ADDENDUM NO. 1

DATE: June 26, 2015

Contract 14-C-00042; Melrose Pump Station Rehabilitation

MELROSE AVENUE PUMPING STATION
 REPLACEMENT
 PROPOSED PLANS - PLAN VIEW

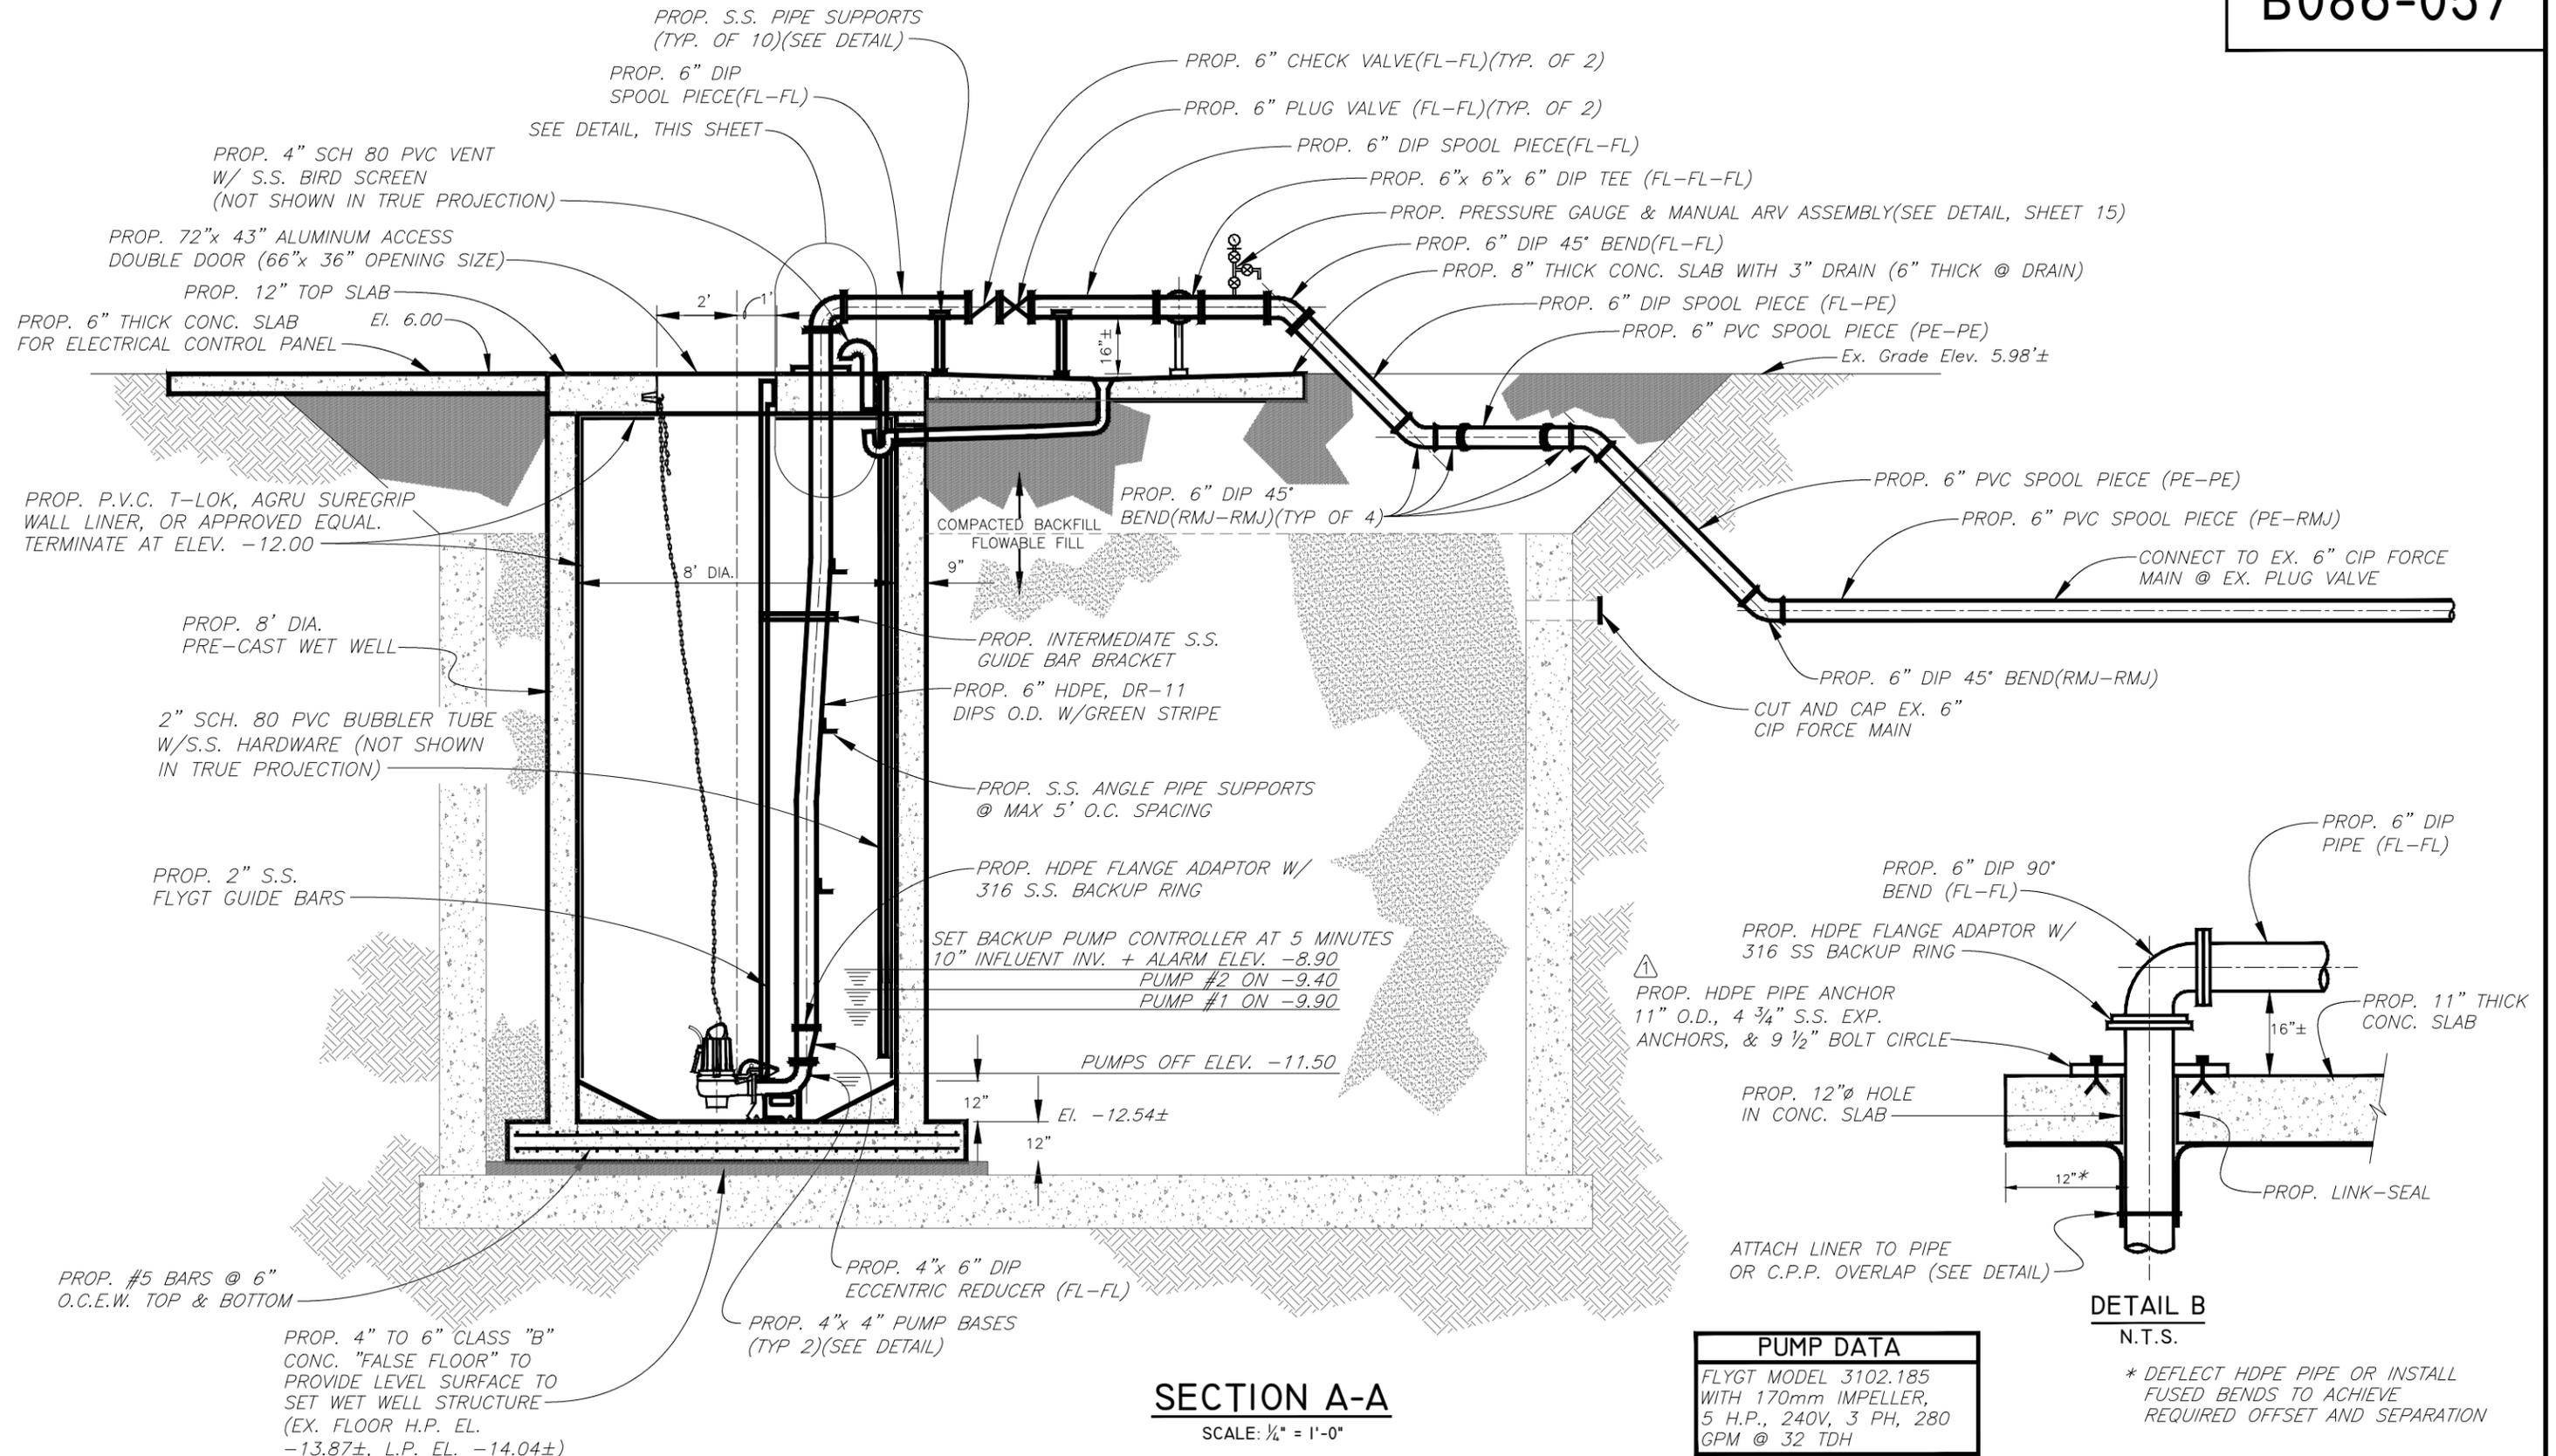
No.	DATE	REVISIONS
3		
2		
1	06/26/15	ADDED PROPOSED WATER CONNECTION LINES AND NOTES & PUMP DATA

PUMP DATA	
FLYGT MODEL 3102.185	
WITH 170mm IMPELLER,	
5 H.P., 240V, 3 PH, 280	
GPM @ 32 TDH

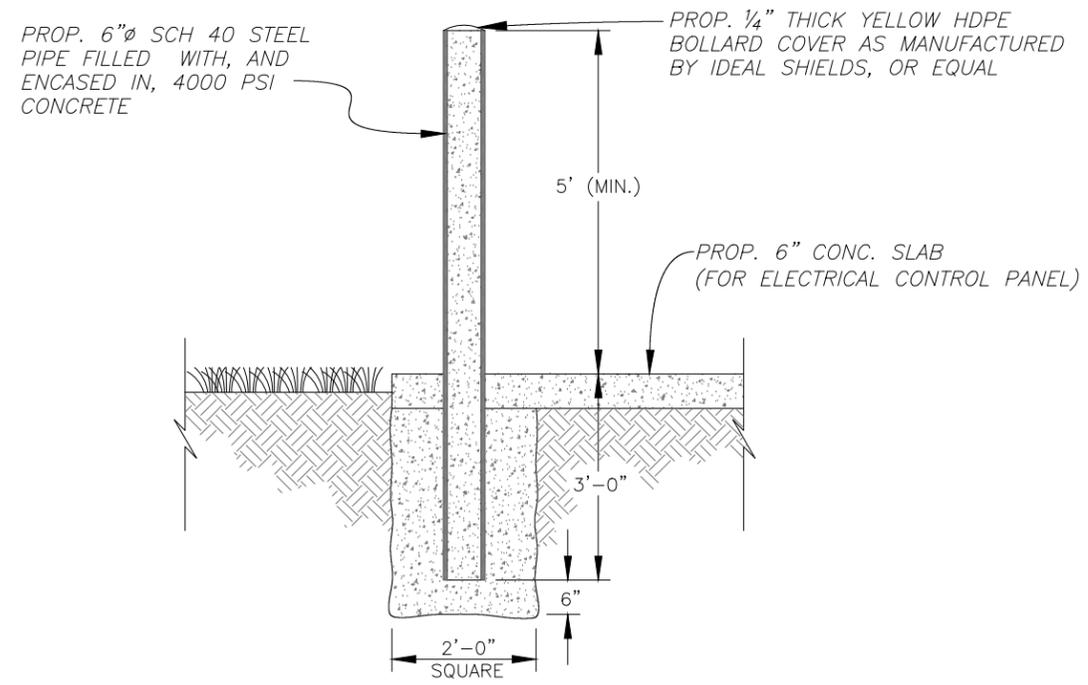
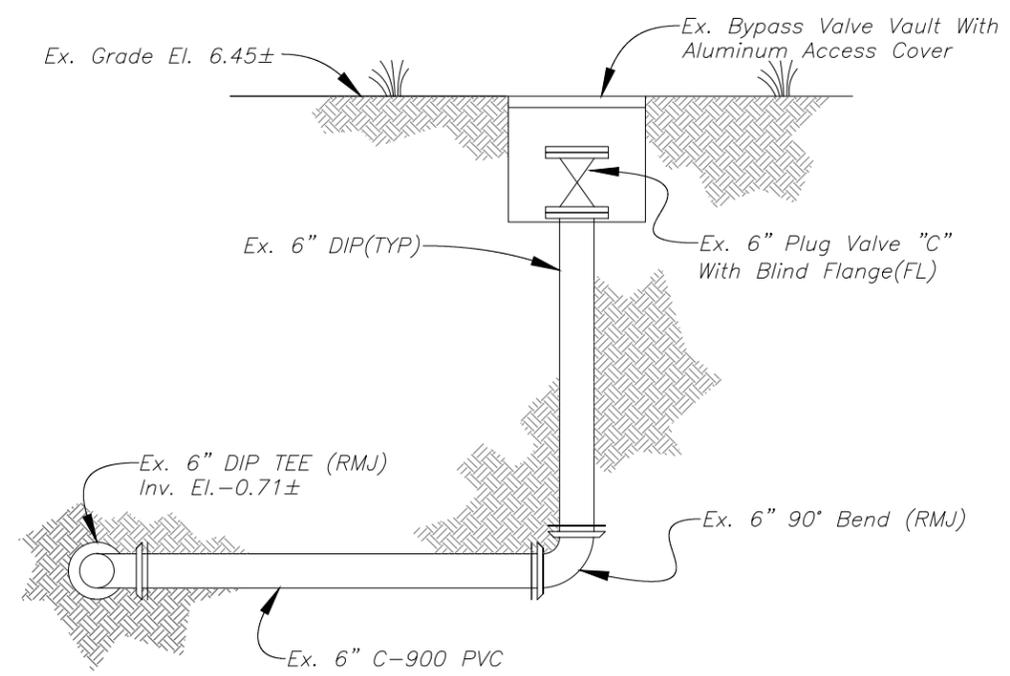
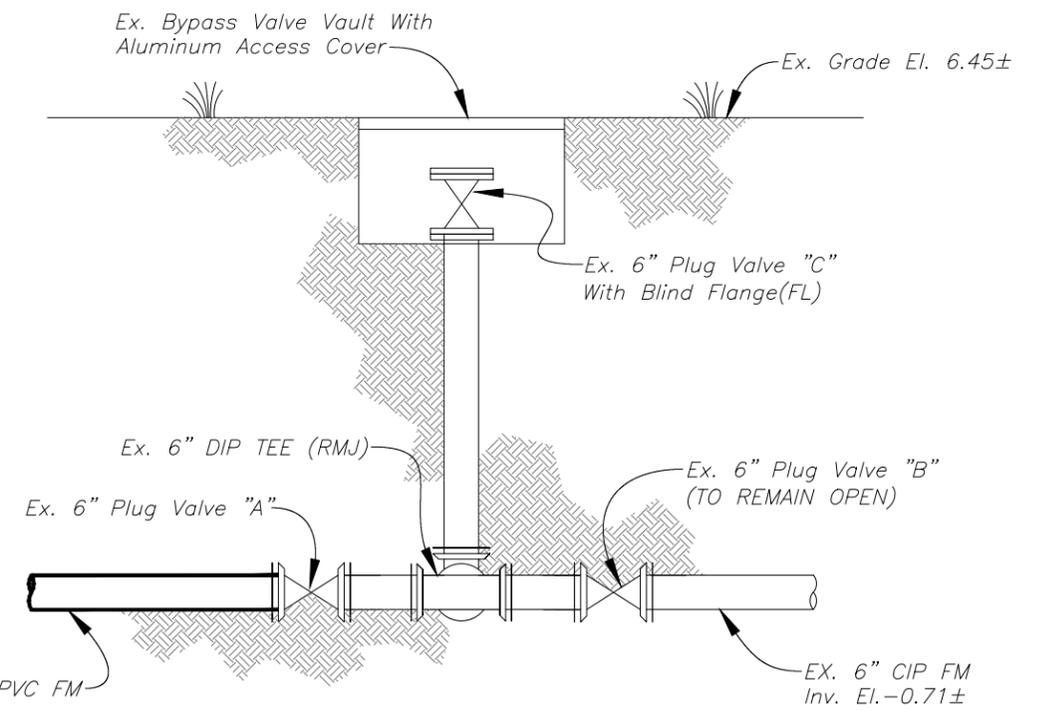
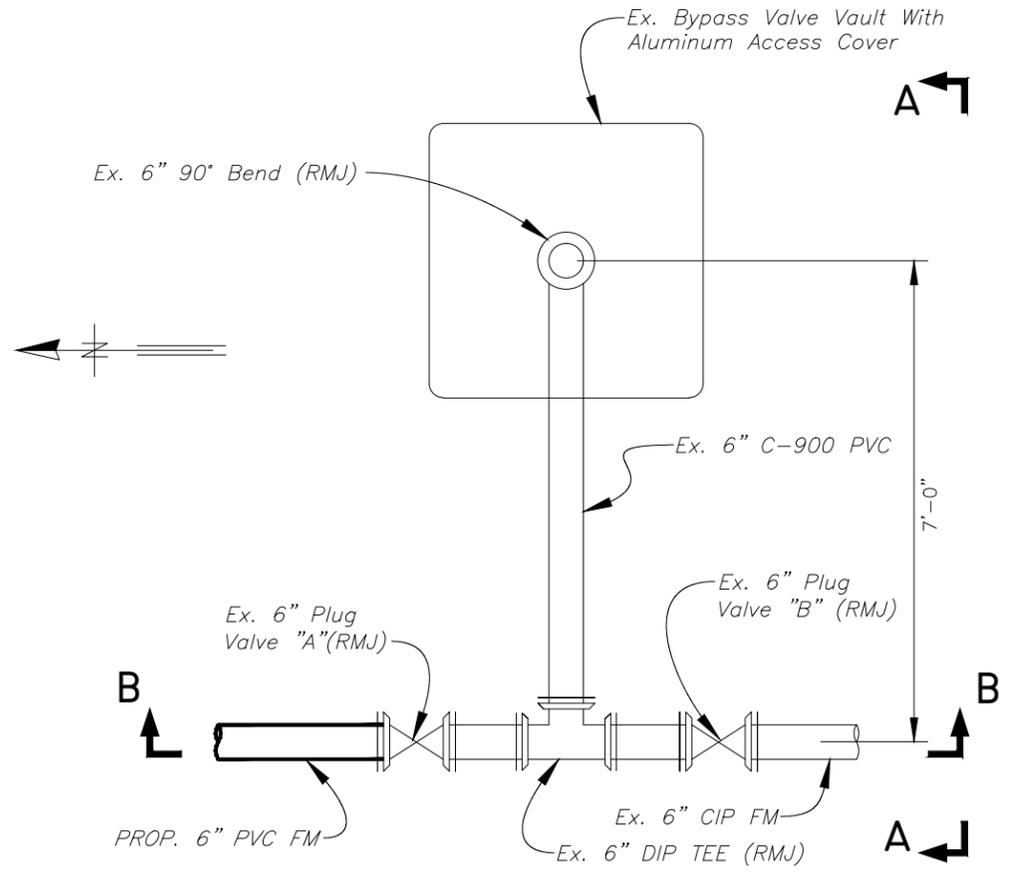
JACINTO CARLOS FERRAS, P.E. #49454 DESIGN DIVISION HEAD WASTEWATER DEPARTMENT	No.	DATE	REVISIONS	DES: CB	CITY of TAMPA WASTEWATER DEPARTMENT	MELROSE AVE. PUMPING STATION REPLACEMENT EXISTING BYPASS VALVE VAULT AND BOLLARD DETAILS	W.O.1000061
	3			DRN: BB			SHEET
	2			CKD:			19
	Δ	06/26/15	THIS SHEET ADDED BY ADDENDUM	DATE:

- 1) CONTRACTOR SHALL VERIFY ACTUAL POSITION OF PLUG VALVE "C" BEFORE REMOVING BLIND FLANGE. THE CITY BELIEVES THE VALVE IS IN THE CLOSED POSITION. VALVE "C" SHALL BE CLOSED PRIOR TO STEP 2.
- 2) REMOVE 6" BLIND FLANGE AND CONNECT TO EXISTING PLUG VALVE "C"
- 3) OPEN PLUG VALVE "C"
- 4) CLOSE PLUG VALVE "A"
- 5) PLUG VALVE "B" TO REMAIN OPEN
- 6) START-UP BYPASS SYSTEM

AFTER CONSTRUCTION IS COMPLETE AND THE NEW PUMP STATION HAS BEEN TESTED AND APPROVED, PLUG VALVE "A" SHALL BE OPENED AND PLUG VALVE "C" SHALL BE CLOSED AND BLIND FLANGE INSTALLED.
